Brewery Yard, Central Park Sydney

Response to Submissions: City of Sydney

Response to City of Sydney Submission

These notes are prepared in response to comments made by the City of Sydney in relation to SSD-9374 and it should be read in conjunction with related correspondence by Ethos Urban and associated consultants.

CS01

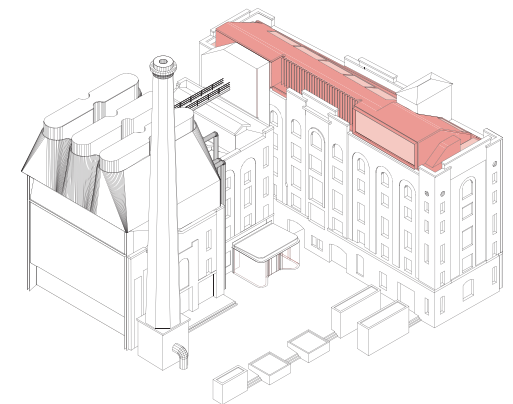
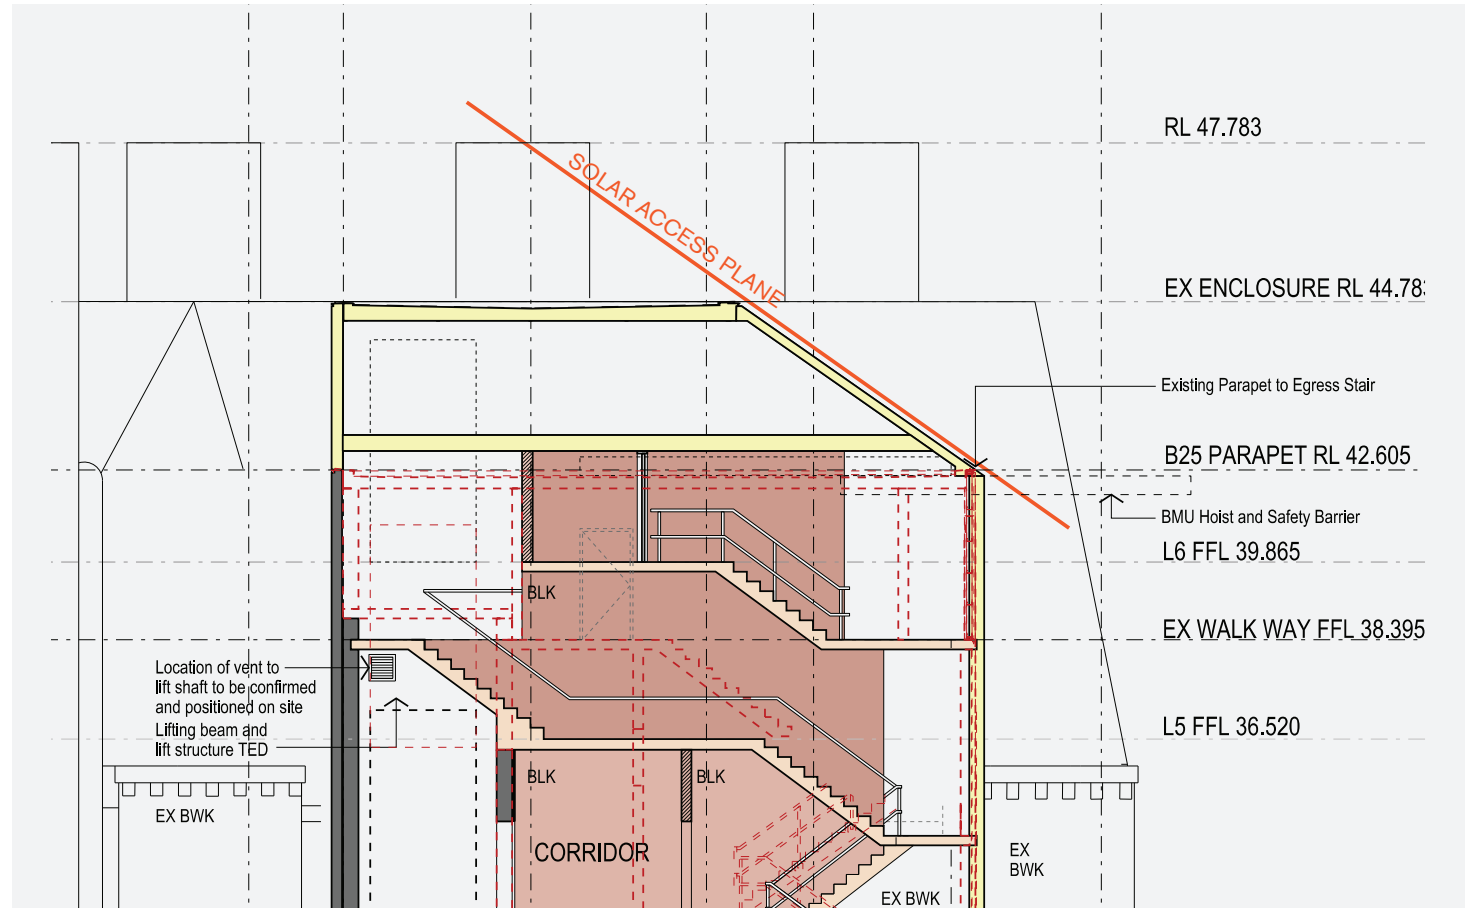
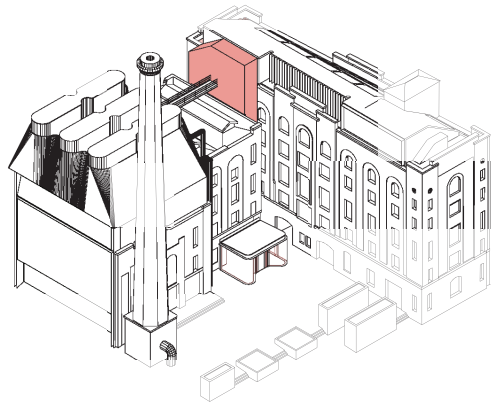
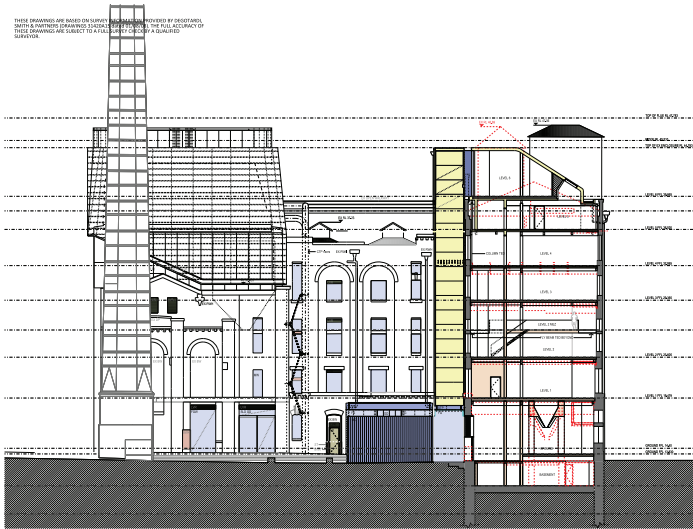
Roof top additions

The new rooftop additions to Building 23 provides additional accommodation at the roof level of this building. They comply with amenity controls designed to protect the park and minimise impact on the heritage character of the view of the most intact aspect of the building, from the south.

In addition they follow the pattern established by the Stage 01 design which looked to add new roof elements which balanced the demands of the new functions as well as the architectural logic of the existing building, creating new roofscapes which are recognisably contemporary.

above
Section showing compliance with the Solar Access plane

CS02

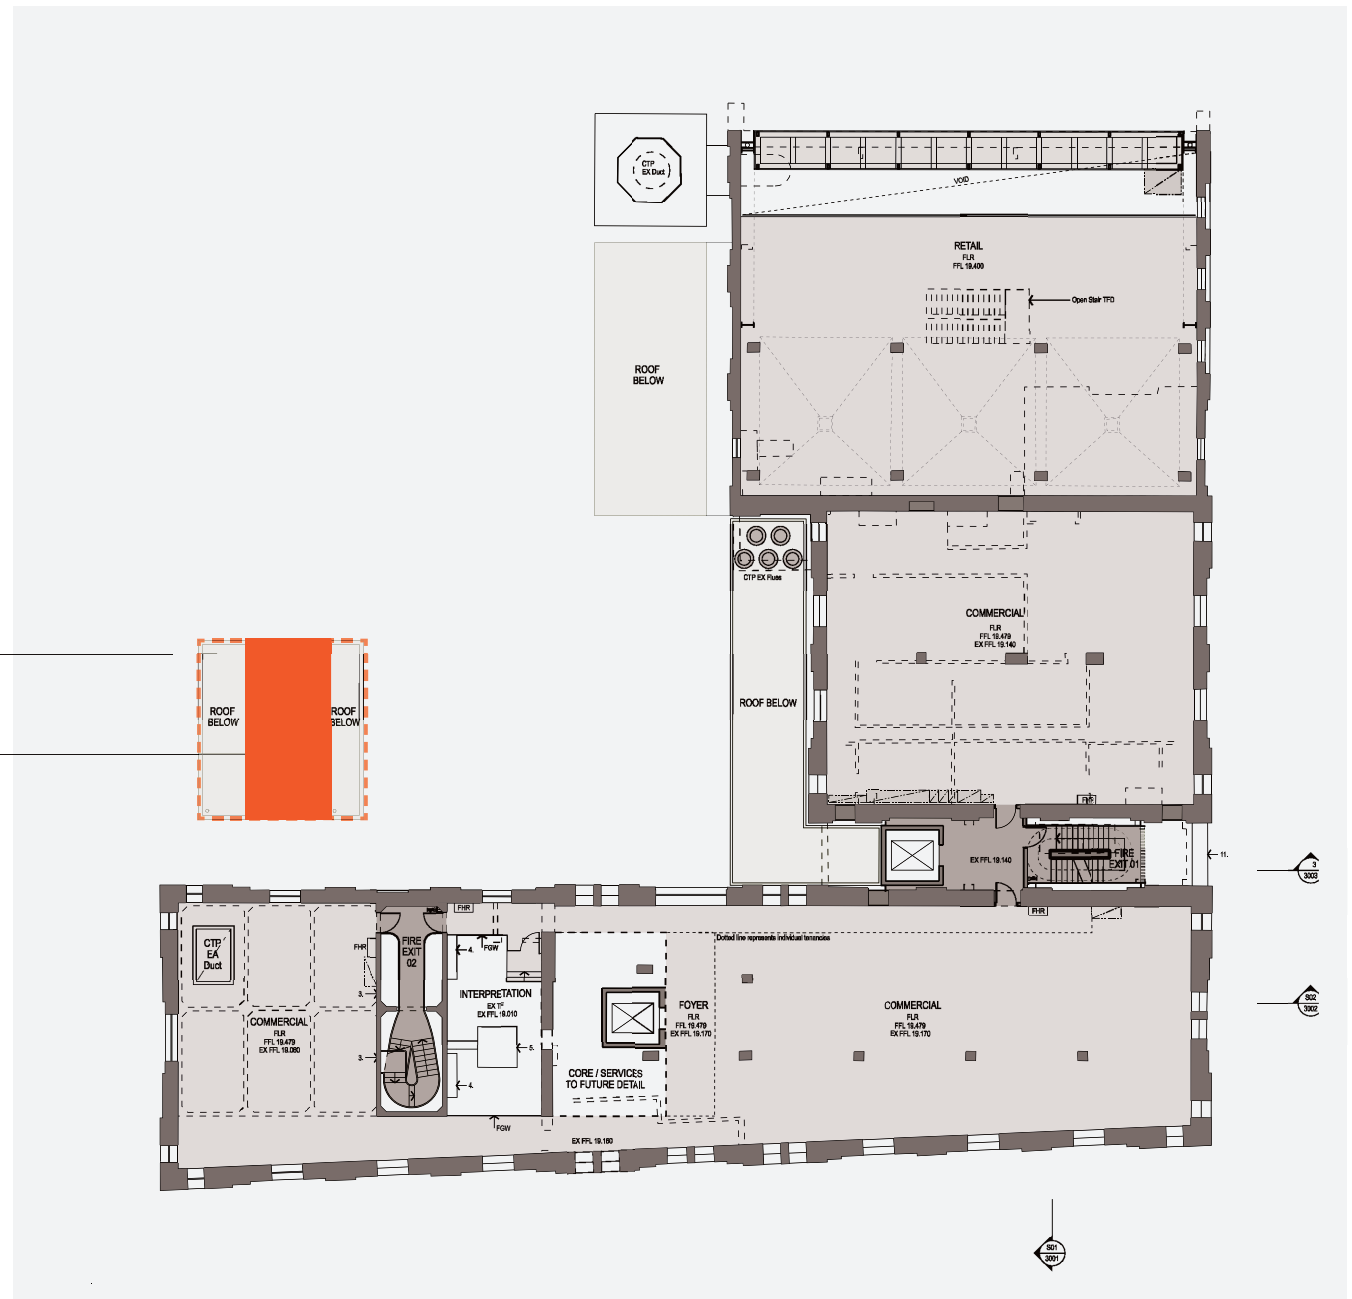
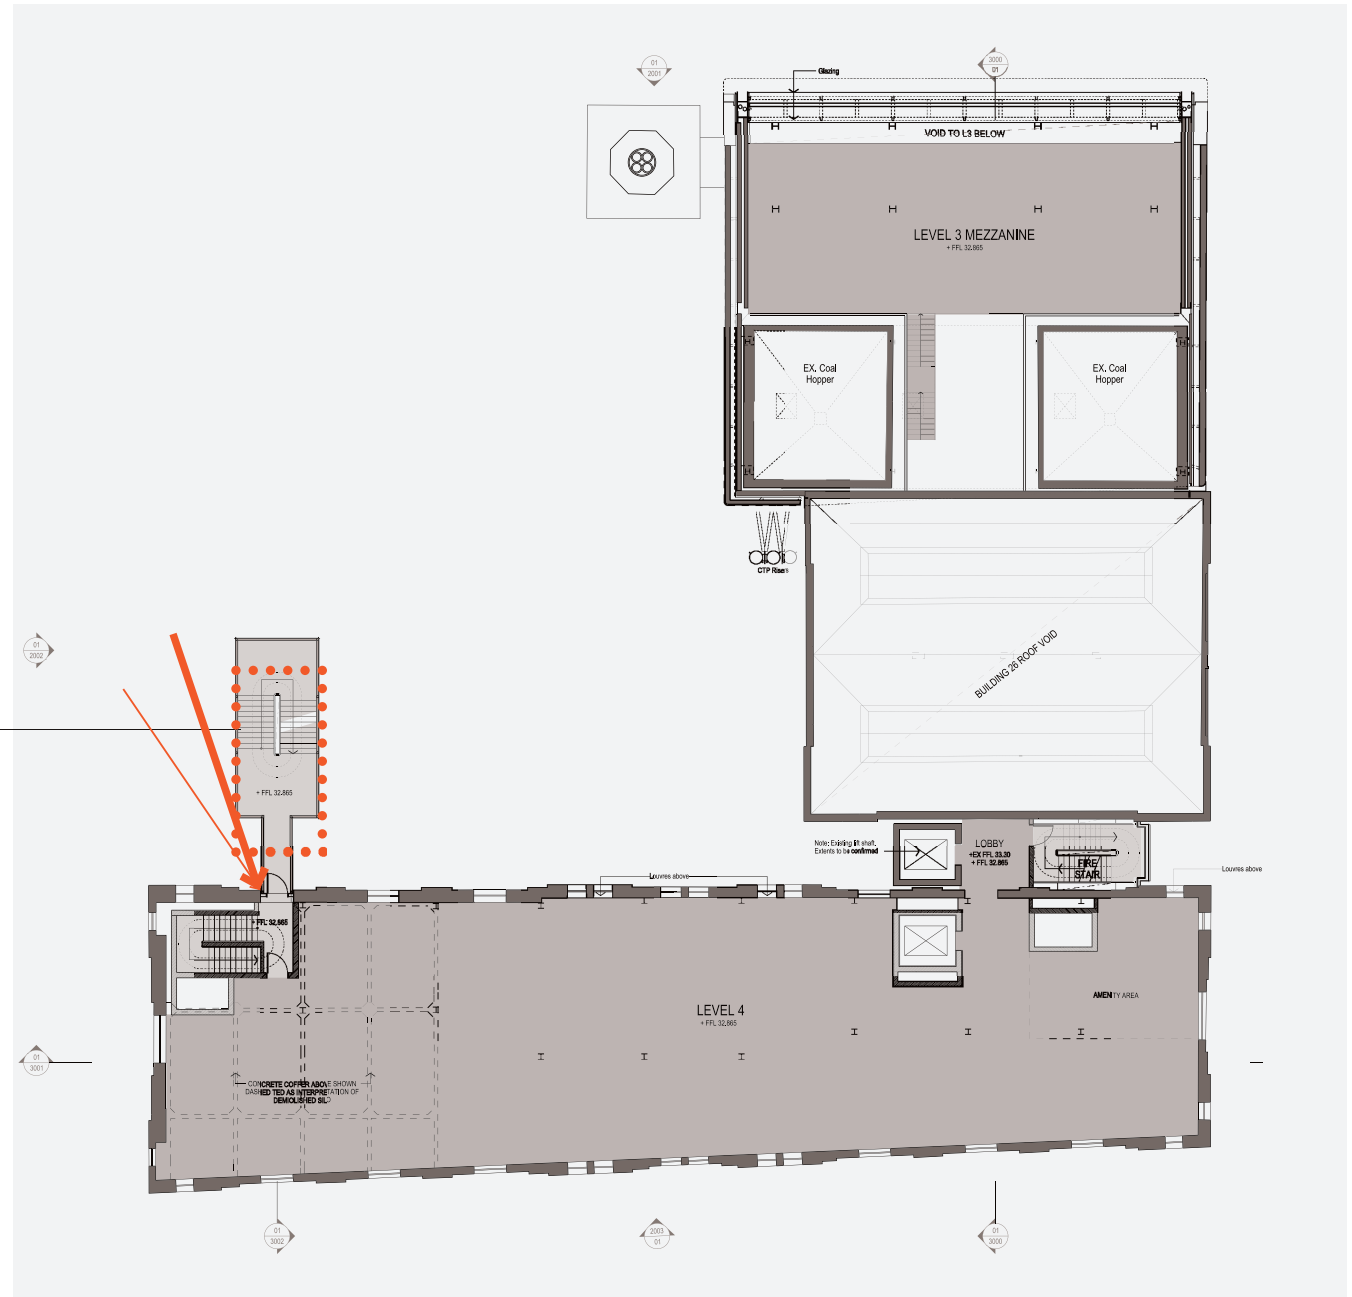
New external stair

The new external stair has been positioned in its current location for a number of important urban design and heritage reasons:

- It integrates the existing built form elements within the existing Brewery Yard public square in the one composition, minimising public domain clutter.
- It allows an appropriate distance from the existing northern wall of the Brewery Building 23. This allows better views of the existing fabric as well as the detailed resolution of the junction of old and new work to be better appreciated.

Approved Ground Floor Plan
Plan showing previously approved and constructed elements
in the square. The new stair shown in red is designed
to integrate these elements in the public domain

Arrows demonstrate how view lines to the existing
fabric are opened up by the current stair set out
compared to reduced set back option

CS03/04

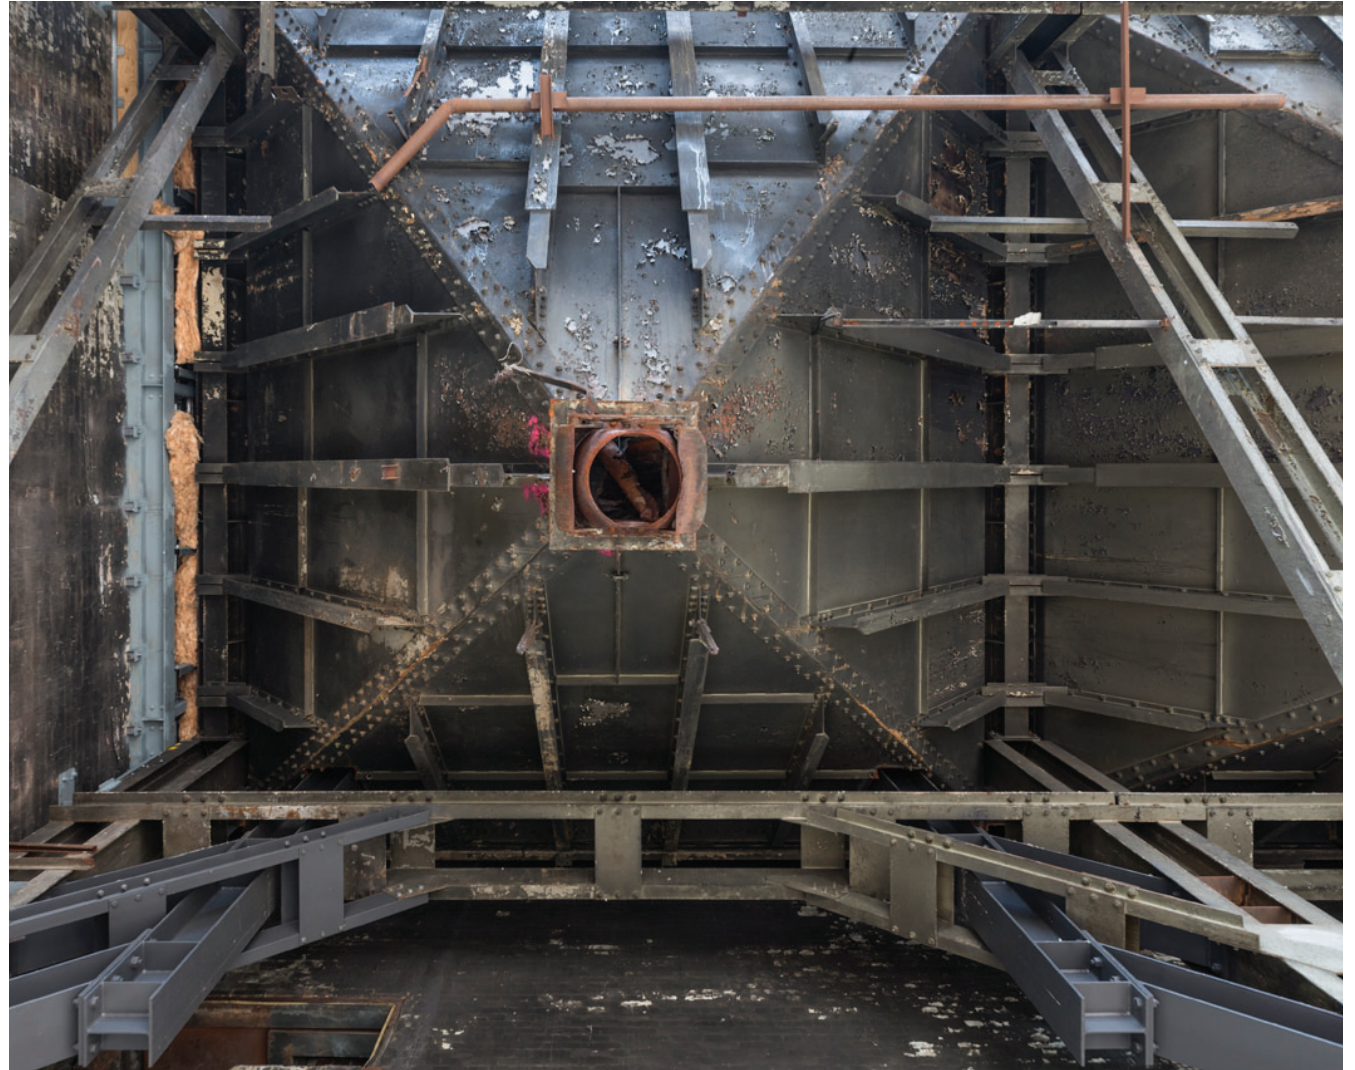
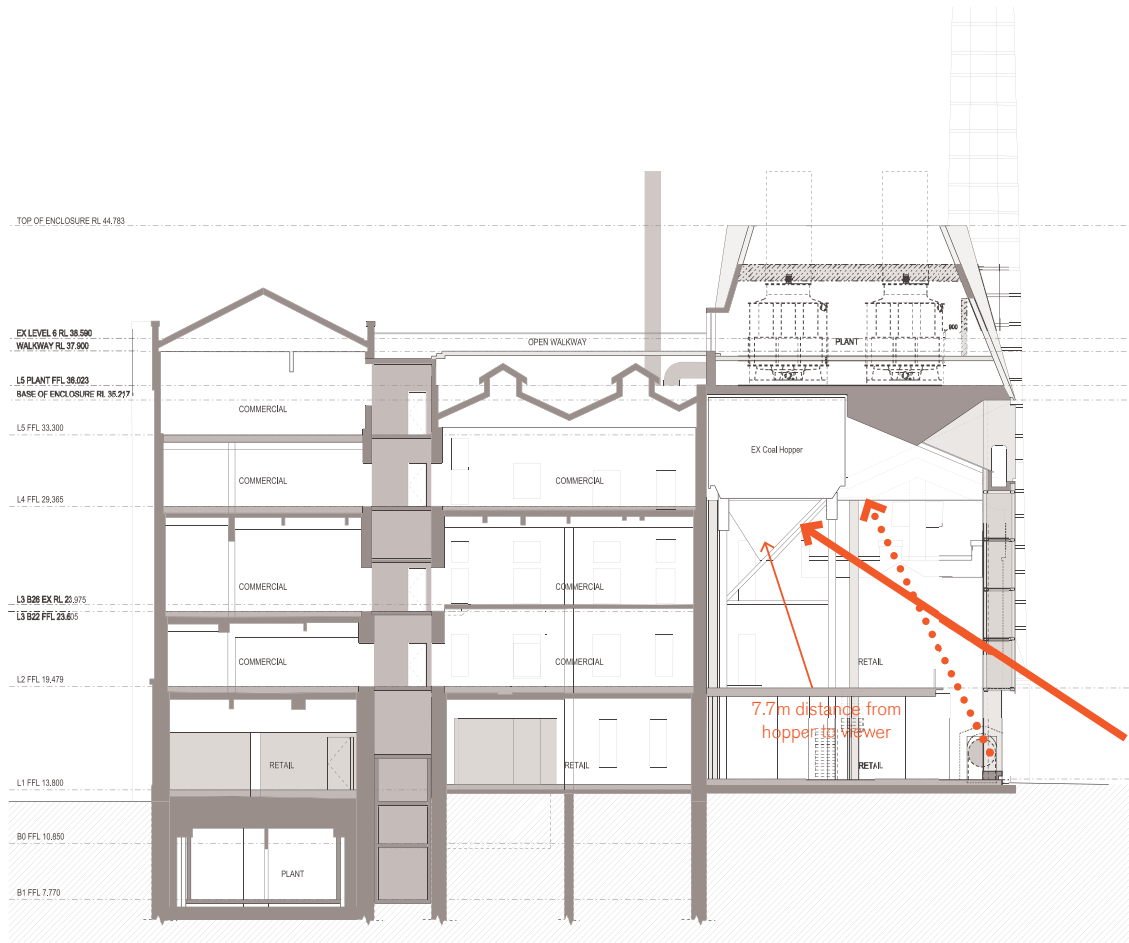
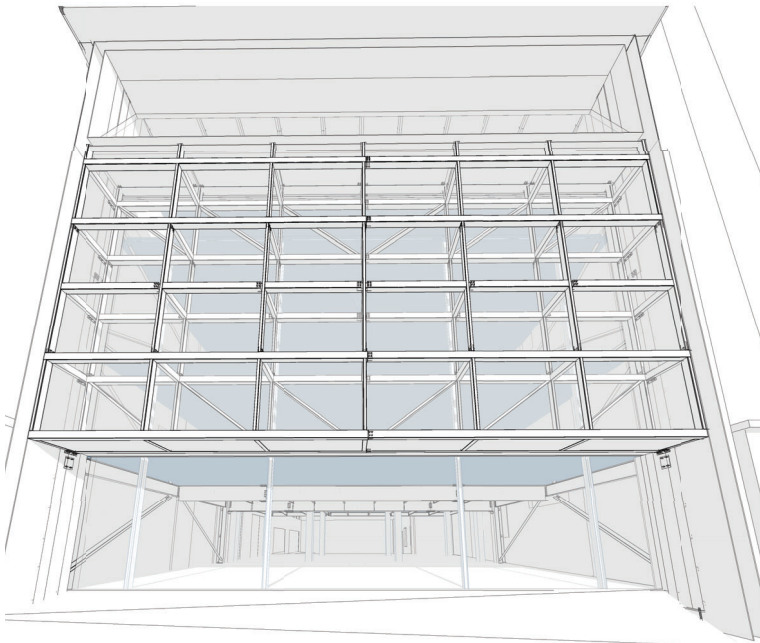
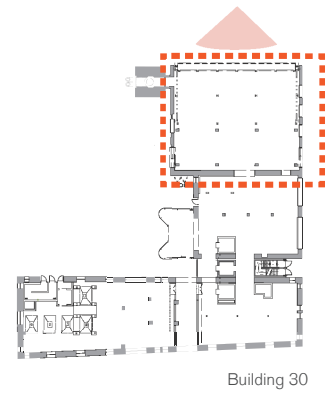
Coal hopper removal and reorganisation of floor levels

The current revised proposal balances views of and interaction with these significant heritage items with the new life of the proposed commercial building.

Under the previous approval, limited access to views were available from the ground floor retail space and was largely limited to views from the public domain. There was no close interaction with the heritage items.

The DA proposal integrated new floor space into this volume allowing significantly closer interaction with these heritage objects albeit with the removal of one of the hoppers to allow equal access. This also had the impact of limiting visual connection to the hoppers from the public domain.

A design alternative developed during the consultation with the CoS maintains the interpretive potential of close contact with the retained hoppers in different floor levels, with better visual connection from the public domain through the redistribution of floors and voids in this space.

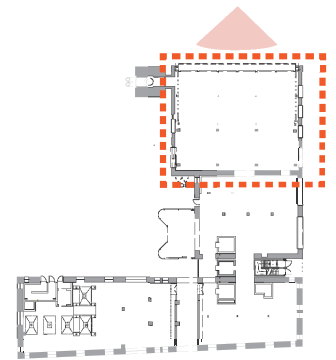
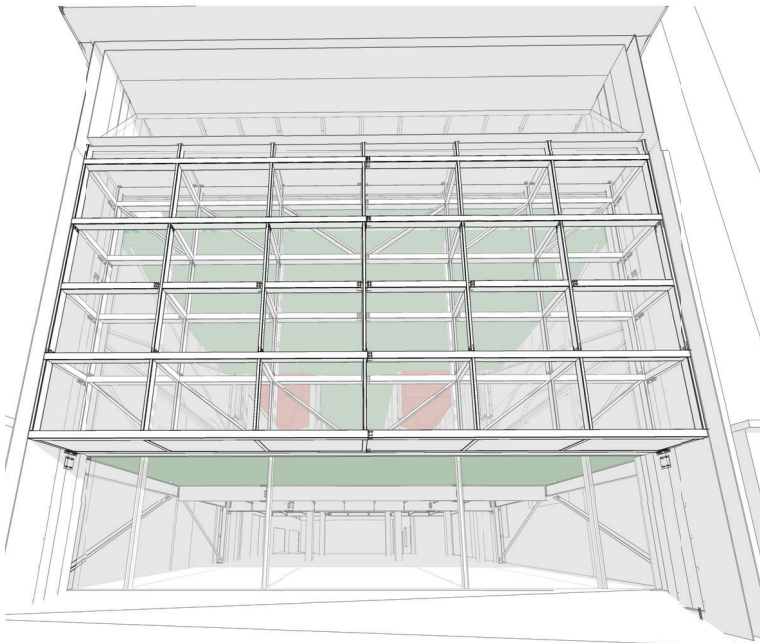
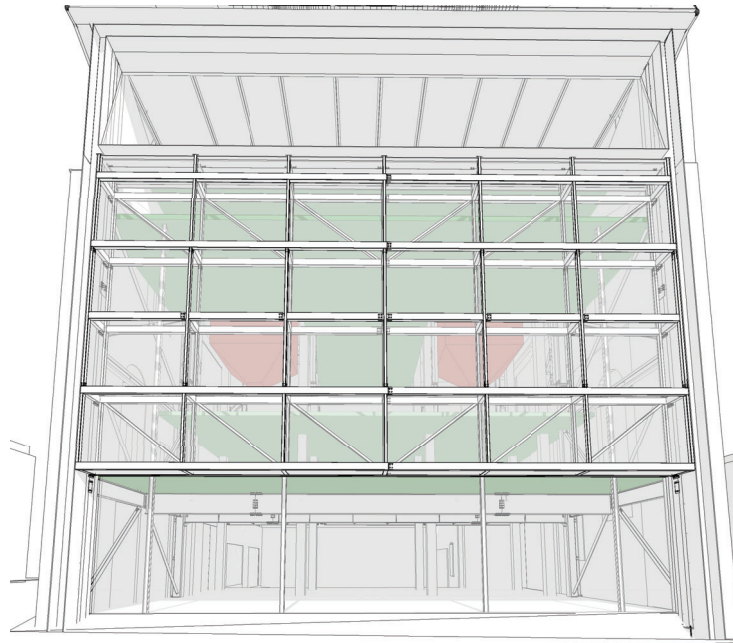
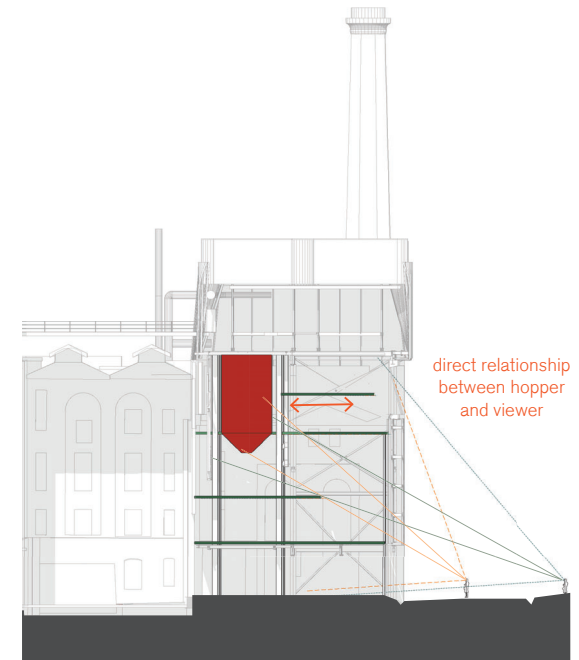
Revised SSDA design following consultation with the CoS showing improved views from the public domain of the coal hoppers resulting from the redistribution of floor slabs in the northern room. The significant view to the bottom of the hoppers is also maximised following the redistribution of floor slabs design. This scheme allows for better interaction between each floor level and the hoppers.

Fire engineering strategies were considered to remove the glass around the hoppers, however none of the strategies met the minimum fire separation regulations for a space over 3 levels.

New proposed scheme.
View from footpath (4m from facade)

New proposed scheme.
View from footpath (15m from facade)
